Evaluation of Physical Barriers – Riverside Downtown Station

Address: 4066 Vine St, Riverside, CA 92507

Evaluation Date: 07-26-2021

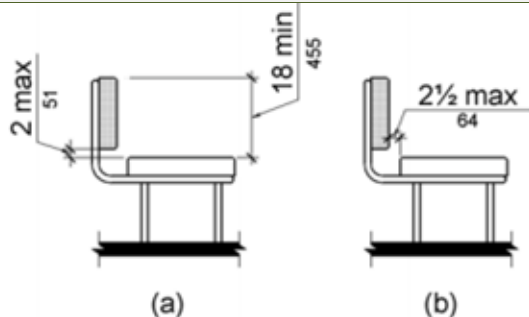
Issues/Barriers Identified	Recommendations	Comments /ADA Requirements						
<div><div><div>i.</div><div>At pedestrian rail crossing in the middle of North loading platform, the ramp slope exceeds 1:12 (8.33%). Slope measured as 8.8 % on one side and 9.6% on the other side. The route was kept closed on the day of evaluation. The ramp is 36 inches wide (not including DWS) with handrails only on one side. The rise is greater than 6 inches.</div><div>Existing ramps do not comply with the then applicable 1991 standards nor with current DOT or 2010 ADA standards for ramps.</div></div><div><div></div><div></div></div></div>	<div><div>Remove handrails and replace the ramps with walkways no more than 1:20 slope.</div><div>Note: Safe Harbor <u>does not</u> apply as the ramp slope requirements in 1991 and 2010 ADA standards are the same</div></div>	<div><div>DOT and 2010 ADA Standards: 405.2 Slope. Ramp runs shall have a running slope not steeper than 1:12. EXCEPTION: In existing sites, buildings, and facilities, ramps shall be permitted to have running slopes steeper than 1:12 complying with Table 405.2 where such slopes are necessary due to space limitations.</div><div><div>Table 405.2 Maximum Ramp Slope and Rise for Existing Sites, Buildings, and Facilities</div>

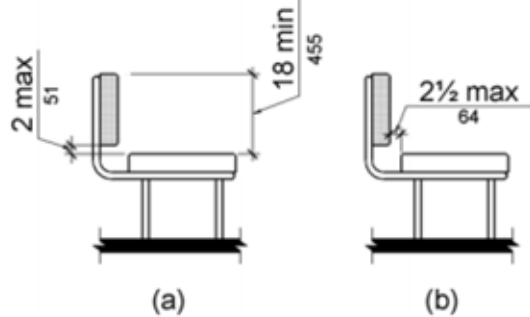
<p>b. Mini High Platforms</p>		
<p>i. The wide ramp at rail crossing (towards SOC) has a cross slope exceeding 2% (3.3%)</p> 	<p>Repair cross slope.</p>	<p>403.3 Slope. The running slope of walking surfaces shall not be steeper than 1:20. The cross slope of walking surfaces shall not be steeper than 1:48 (2%)</p>

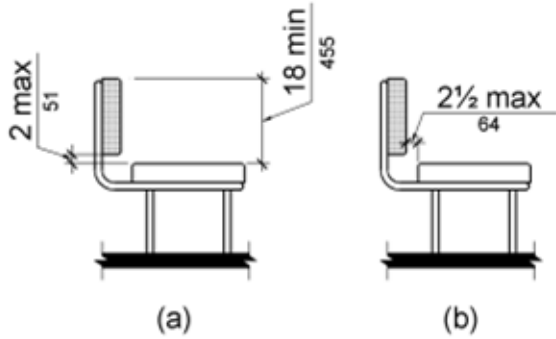
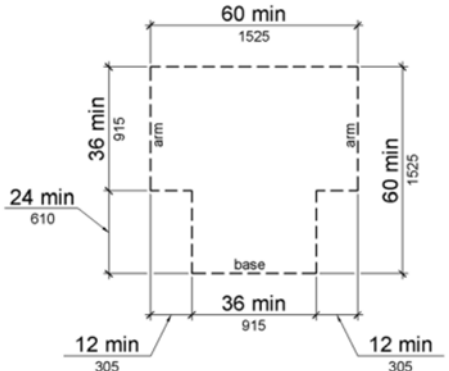
Issues/Barriers Identified	Recommendations	Comments /ADA Requirements
<p>b) Drinking Fountains</p> <p>i. Water flow in drinking fountain needs to be adjusted.</p> <p>ii. Near the main entrance, clear space for an existing fountain is blocked by a trash can.</p> <div data-bbox="121 338 891 641">  </div>	<p>Adjust waterflow and Relocate trash can.</p>	<p>602.6 Water Flow. The spout shall provide a flow of water 4 inches (100 mm) high minimum and shall be located 5 inches (125 mm) maximum from the front of the unit. The angle of the water stream shall be measured horizontally relative to the front face of the unit. Where spouts are located less than 3 inches (75 mm) of the front of the unit, the angle of the water stream shall be 30 degrees maximum. Where spouts are located between 3 inches (75 mm) and 5 inches (125 mm) maximum from the front of the unit, the angle of the water stream shall be 15 degrees maximum.</p>
